Access Audit Site Report

Ft. Leaton State Historic Site

Accessibility Evaluation

Inspection Date: 09/22/2021

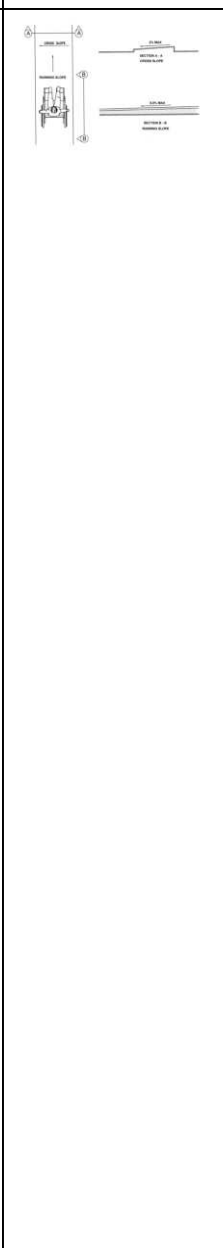
Finding Number	Area Description	Lat/Long	Finding	As Built	Recommendation	Citation	Photos	Figure
4	Exterior: Exterior Accessible Route	[29.5429744 , -104.3260 068]	The running slope of walking surfaces shall not be steeper than 1:20.	5.5% running slope to cemetery and overlapping sign CFS, 8.4% to nature trail, 5.5% near cemetery sign, 7.1% heading uphill towards cemetery	Correct running slope along the AR to max 5%.	2015 ABAAS Section: 403.3 2012 TAS Section: 403.3 2010 ADAS Section: 403.3		
5	Exterior: Exterior Accessible Route	[29.5430255 , -104.3260 852]	The walkway contains abrupt vertical edges and/or variations over a 1/4 inch. 1/4 inch is the maximum vertical rise. Changes in level between 1/4 inch and 1/2 inch must be beveled at 1:2 or less. Changes in level greater than 1/2 inch must be by way of a ramp.	CIL where sidewalk drops off to nature trail	Repair, bevel or ramp CIL along AR.	2012 TAS Section: 303.2, 303.3 2010 ADAS Section: 303.2, 303.3

6	Exterior: Exterior Accessible Route	[29.5425147 , -104.3261 999]	The accessible route of travel on the accessible route contains cross slopes greater than 2%. Cross slopes shall not exceed one unit vertical in 48 units horizontal (2-percent slope).	Cross slope of 4.4% at section where the new and old entrance path intersect	Correct or repair cross slope along AR to max 2.08%.	2015 ABAAS Section: 403.3 2012 TAS Section: 403.3 2010 ADAS Section: 403.3

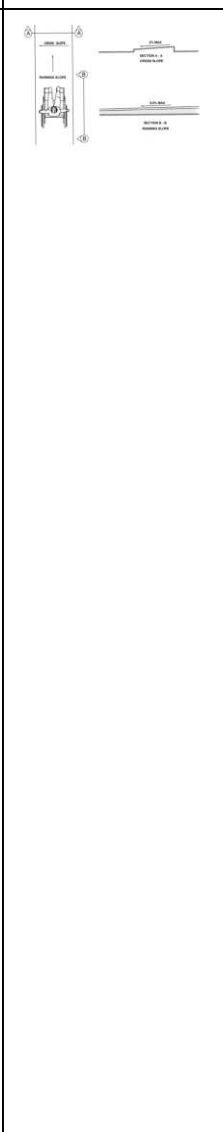
Finding Number	Area Description	Lat/Long	Finding	As Built	Recommendation	Citation	Photos	Figure
7	Exterior: Exterior Accessible Route	[29.5423412, -104.3264619]	The accessible route contains loose gravel and/or surfaces that do not provide for a stable, firm slip resistant surface.	Most of the older section of the entrance path has cracks exceeding .5", with deterioration causing CILs exceeding .25"	Resurface AR where deterioration occurs.	2015 ABAAS Section: 302.1 2012 TAS Section: 302.1 2010 ADAS Section: 302.1		
8	Exterior: Exterior Accessible Route	[29.5426212, -104.3252938]	The walkway contains abrupt vertical edges and/or variations over a 1/4 inch. 1/4 inch is the maximum vertical rise. Changes in level between 1/4 inch and 1/2 inch must be beveled at 1:2 or less. Changes in level greater than 1/2 inch must be by way of a ramp.	CIL exceeding .25" at transition from parking to picnic area	Repair, bevel or ramp CIL along AR.	2012 TAS Section: 303.2, 303.3 2010 ADAS Section: 303.2, 303.3

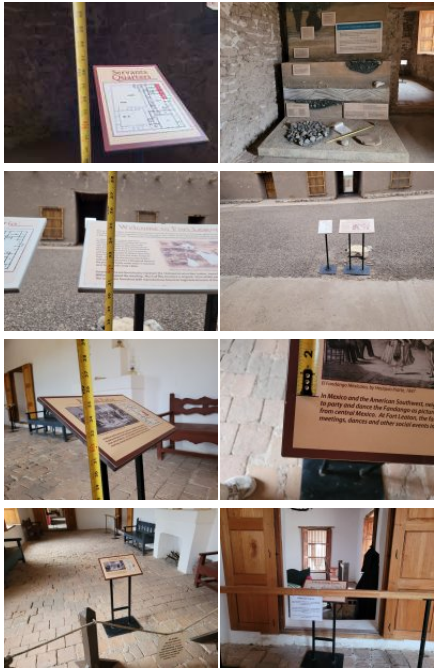
Finding Number	Area Description	Lat/Long	Finding	As Built	Recommendation	Citation	Photos	Figure
18	Fort Leaton: Public Spaces	[29.5423805 ,-104.3263 408]	The route of travel at this location does not provide a minimum width of 36 inches. The clear width shall be permitted to be reduced to 32 inches minimum for a length of 24 inches maximum provided that reduced width segments are separated by segments that are 48 inches long minimum and 36 inches wide minimum.	Servant's quarters (4,5,6) - Route narrows to 31" to enter the rear space (6)	Widen AR to compliant 36" clear width.	2015 ABAAS Section: 403.5.1 2012 TAS Section: 403.5.1 2010 ADAS Section: 403.5.1		
19	Fort Leaton: Public Spaces	[29.542384, -104.32636 62]	The entryway extends down too close to the route of travel. Any obstruction that overhangs a route of travel must be a minimum of 80 inches above the walking surface as measured from the bottom of the obstruction.	Servant's quarters (4,5,6) - Entry height at 75" AFF	Raise entry to min 80", or pad object to prevent hazard in overhead clearance along AR.	2015 ABAAS Section: 307.4 2012 TAS Section: 307.4 2010 ADAS Section: 307.4

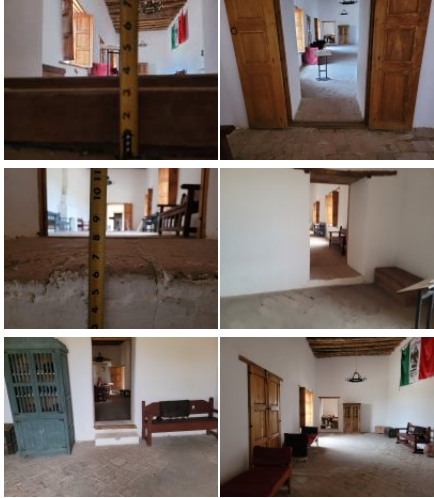
Finding Number	Area Description	Lat/Long	Finding	As Built	Recommendation	Citation	Photos	Figure
20	Fort Leaton: Public Spaces	[29.542377, -104.3263662]	There is a change in level greater than 1/4 inch. 1/4 inch is the maximum vertical rise. Changes in level between 1/4 inch and 1/2 inch must be beveled at 1:2 or less. Changes in level greater than 1/2 inch must be by way of a ramp.	Servant's quarters (4,5,6) - Original flooring has multiple CILs, 6" threshold between space 4 and 5, multiple CILs from entry into space 4	Repair, bevel or ramp CIL along AR to max .25".	2015 ABAAS Section: 303.3 2012 TAS Section: 303.3 2010 ADAS Section: 303.3		
21	Fort Leaton: Public Spaces	[29.5424167, -104.326318]	The route of travel at this location does not provide a minimum width of 36 inches. The clear width shall be permitted to be reduced to 32 inches minimum for a length of 24 inches maximum provided that reduced width segments are separated by segments that are 48 inches long minimum and 36 inches wide minimum.	Formal parlor (3) - Lacks 36" route of travel - 28" between post and signs	Relocate posts and signs to provide compliant 36" clear width	2015 ABAAS Section: 403.5.1 2012 TAS Section: 403.5.1 2010 ADAS Section: 403.5.1

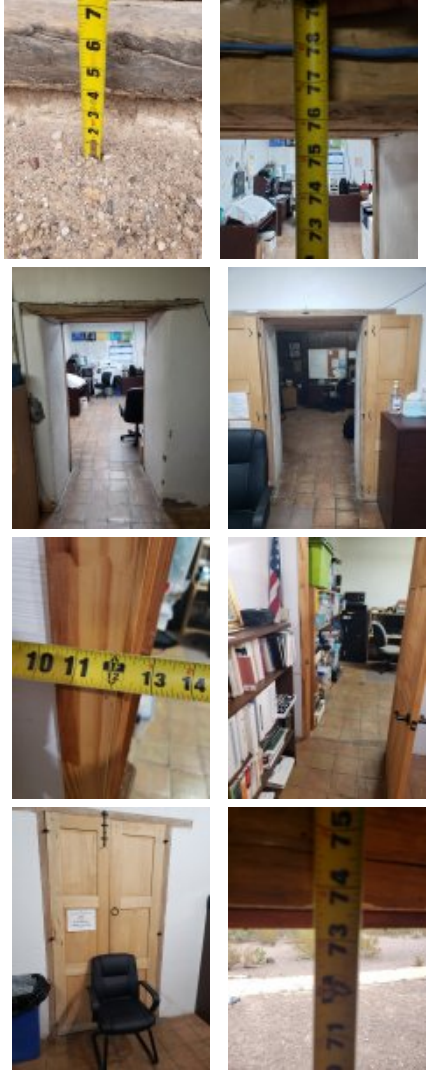
Finding Number	Area Description	Lat/Long	Finding	As Built	Recommendation	Citation	Photos	Figure
52	Fort Leaton: Public Spaces	[29.5424447, -104.3265915]	There is a gap spaced greater than a 1/2 inch. Openings in floor or ground surfaces shall not allow passage of a sphere more than 1/2 inch diameter. Elongated openings shall be placed so that the long dimension is perpendicular to the dominant direction of travel.	1" gap and multiple similar where surface cracked in courtyard	Correct or fill gaps to be max .5".	2015 ABAAS Section: 302.3 2012 TAS Section: 302.3 2010 ADAS Section: 302.3		
53	Fort Leaton: Public Spaces	[29.54251, -104.3265]	The accessible route of travel on the accessible route contains cross slopes greater than 2%. Cross slopes shall not exceed one unit vertical in 48 units horizontal (2-percent slope).	5.8% cross slope between entry and store, 4.8% near courtyard signage	Correct or repair cross slope along AR to max 2.08%.	2015 ABAAS Section: 403.3 2012 TAS Section: 403.3 2010 ADAS Section: 403.3

54	Fort Leaton: Public Spaces	[29.542386, -104.3265496]	The walkway contains abrupt vertical edges and/or variations over a 1/4 inch. 1/4 inch is the maximum vertical rise. Changes in level between 1/4 inch and 1/2 inch must be beveled at 1:2 or less. Changes in level greater than 1/2 inch must be by way of a ramp.	CIL where deteriorated at entry gate	Repair, bevel or ramp CIL along AR.	2012 TAS Section: 303.2, 303.3 2010 ADAS Section: 303.2, 303.3

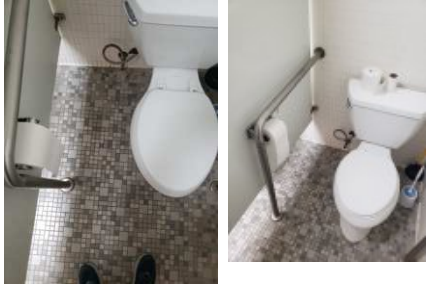
66	Fort Leaton: Men's Restroom	[29.5425497 , -104.32644 4]	There are not enough accessible toilet compartments. The room contains several toilet compartments. A minimum of 1 must be wheelchair accessible .	Ambulatory only	Create a wheelchair accessible stall with grab bars and fixtures mounted in correct locations and at correct heights.	2015 ABAAS Section: F213.3.1 2012 TAS Section: 213.3.1 2010 ADAS Section: 213.3.1

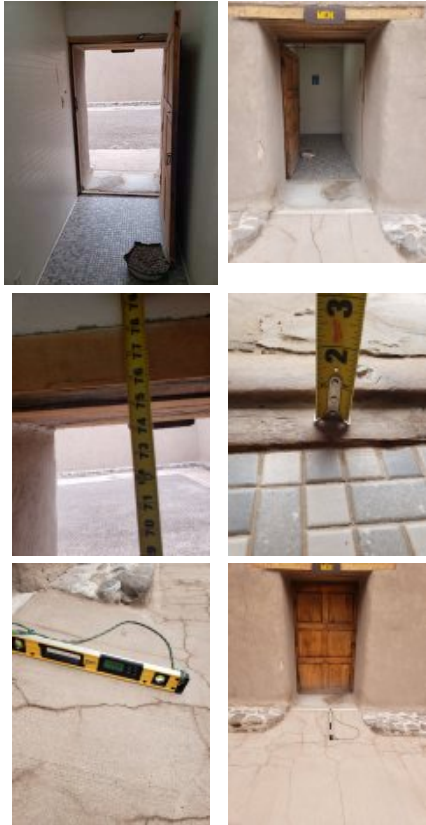
Finding Number	Area Description	Lat/Long	Finding	As Built	Recommendation	Citation	Photos	Figure
67	Fort Leaton: Men's Restroom	[29.542559, -104.32646 01]	The ambulatory stall is not between 35" to 37" wide and 60" deep.	Ambulatory stall lacks required dimensions - 38" wide x 55" deep	Correct ambulatory stall to be 35" to 37" wide and minimum 60" deep.	2015 ABAAS Section: 604.8.2.1 2012 TAS Section: 604.8.2.1 2010 ADAS Section: 604.8.2.1		
68	Fort Leaton: Men's Restroom	[29.5425567, -104.3264 574]	The toilet is not located within the range to the side wall or partition. The centerline of the toilet shall be 17 inches minimum and 19 inches maximum side wall or partition in the ambulatory accessible toilet compartment.	22" left, 16" right	Remount toilet to 17" to 19" from the side wall to center line in ambulatory stalls.	2015 ABAAS Section: 604.9.1 2012 TAS Section: 604.9.1 2010 ADAS Section: 604.9.1

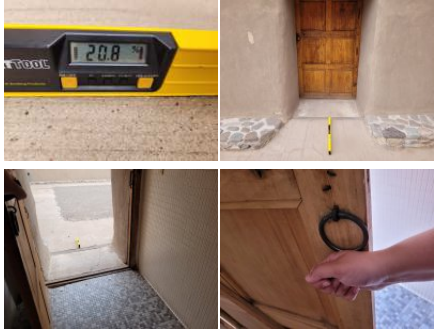
Finding Number	Area Description	Lat/Long	Finding	As Built	Recommendation	Citation	Photos	Figure
80	Fort Leaton: Women's Restroom	[29.5425579, -104.3264561]	The operable part is positioned too high for either a side or front approach. Where a clear floor or ground space allows a parallel approach to an element and the side reach is unobstructed, the high side reach shall be 48 inches maximum and the low side reach shall be 15 inches minimum above the finish floor or ground. Where a forward reach is unobstructed, the high forward reach shall be 48 inches maximum and the low forward reach shall be 15 inches minimum above the finish floor or ground.	Hook at 60.25" AFF	Remount operable parts to be in reach range of 15" min to 48" max.	2015 ABAAS Section: 308.1 2012 TAS Section: 308.1 2010 ADAS Section: 308.1		
81	Fort Leaton: Women's Restroom	[29.5425614, -104.3264548]	There are not enough accessible toilet compartments. The room contains several toilet compartments. A minimum of 1 must be wheelchair accessible .	Ambulatory only	Create a wheelchair accessible stall with grab bars and fixtures mounted in correct locations and at correct heights.	2015 ABAAS Section: F213.3.1 2012 TAS Section: 213.3.1 2010 ADAS Section: 213.3.1

82	Fort Leaton: Women's Restroom	[29.542559, -104.3264521]	The ambulatory stall is not between 35" to 37" wide and 60" deep.	Ambulatory stall lacks required dimensions - 38.5" wide x 55.5" deep	Correct ambulatory stall to be 35" to 37" wide and minimum 60" deep.	2015 ABAAS Section: 604.8.2.1 2012 TAS Section: 604.8.2.1 2010 ADAS Section: 604.8.2.1

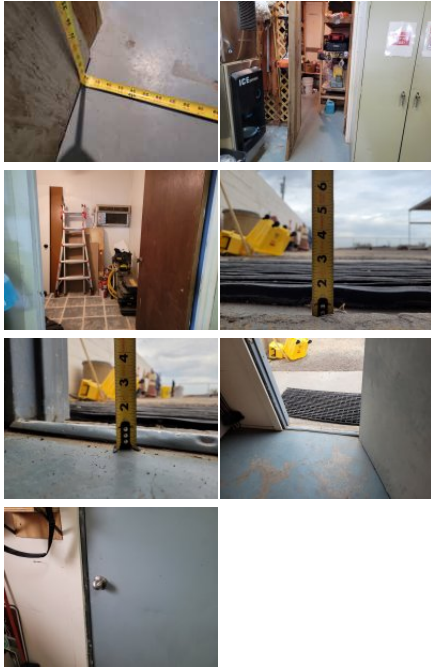
Finding Number	Area Description	Lat/Long	Finding	As Built	Recommendation	Citation	Photos	Figure
83	Fort Leaton: Women's Restroom	[29.5425544, -104.3264548]	The toilet is not located within the range to the side wall or partition. The centerline of the toilet shall be 17 inches minimum and 19 inches maximum side wall or partition in the ambulatory accessible toilet compartment.	22" from one side	Remount toilet to 17" to 19" from the side wall to center line in ambulatory stalls.	2015 ABAAS Section: 604.9.1 2012 TAS Section: 604.9.1 2010 ADAS Section: 604.9.1		
84	Fort Leaton: Women's Restroom	[29.542559, -104.3264574]	The stall door fails to comply with all of the door requirements. The stall door must be a minimum of 32" wide and have compliant hardware on both sides. The stall door must be self-closing.	door 30.5", not self-closing	Widen stall doors to 32" when opened to 90 degrees. Adjust stall door to be self-closing.	2015 ABAAS Section: 404.2.3, 404.2.7, 604.8.2.2 2012 TAS Section: 404.2.3, 404.2.7, 604.8.2.2 2010 ADAS Section: 404.2.3, 404.2.7, 604.8.2.2

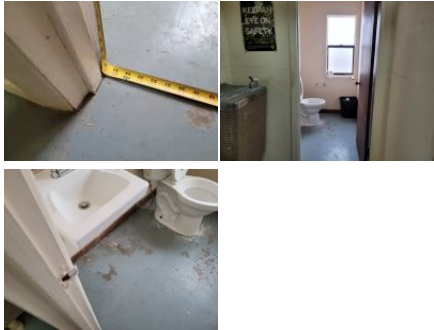
Finding Number	Area Description	Lat/Long	Finding	As Built	Recommendation	Citation	Photos	Figure
88	Fort Leaton: Women's Restroom	[29.542555, -104.3264521]	The route of travel at this location does not provide a minimum width of 36 inches. The clear width shall be permitted to be reduced to 32 inches minimum for a length of 24 inches maximum provided that reduced width segments are separated by segments that are 48 inches long minimum and 36 inches wide minimum.	35" around turn	Widen AR to compliant 36" clear width.	2015 ABAAS Section: 403.5.1 2012 TAS Section: 403.5.1 2010 ADAS Section: 403.5.1		
89	Fort Leaton: Women's Restroom	[29.542556, -104.326451]	Minimum maneuvering clearances at doors and gates shall comply with 404.2.4. Maneuvering clearances shall extend the full width of the doorway and the required latch side or hinge side clearance. Maneuvering clearances shall have a max slope of 2.08%. The sweep period for doors with closers shall be adjusted so that from an open position of 70 degrees, the door will take at least 3 seconds to move to a point 3 inches from the latch, measured to the leading edge of the door. Exterior doors are recommended to be maintained at 8.5 lbf as a smart practice. Force is to be measured at the operating hardware or 30 inches from the hinges, whichever is greater. Hand-activated door opening hardware, handles, pulls, latches, locks, and other operating devices on accessible doors shall have a shape that is easy to grasp with one hand and does not require tight grasping, tight pinching or twisting of the wrist to operate. Hardware shall be 34 inches minimum and 48 inches maximum above the finish floor or ground.	Women's restroom door - 20.8% in push side maneuvering clearance, recessed push side, recessed/wall pull side, 11# push, hardware does not comply, closes fast	For all doors along the public circulation route, provide required maneuvering clearance on push and pull side of doors. For all doors along the public circulation route, correct slope in door clearance to max 2.08%. For all doors along the public circulation route, inspect, adjust, and maintain closing speed on door closers. For all doors along the public circulation route, inspect, adjust, and maintain 8.5 lbf to open exterior doors as a smart practice. For all doors along the public circulation route, replace hardware with lever hardware or hardware operable without a tight pinch or grasp.	2010 ADAS Section: 404.2.3, 404.2.7, 404.2.4, 404.2.11, 404.2.11 Exception
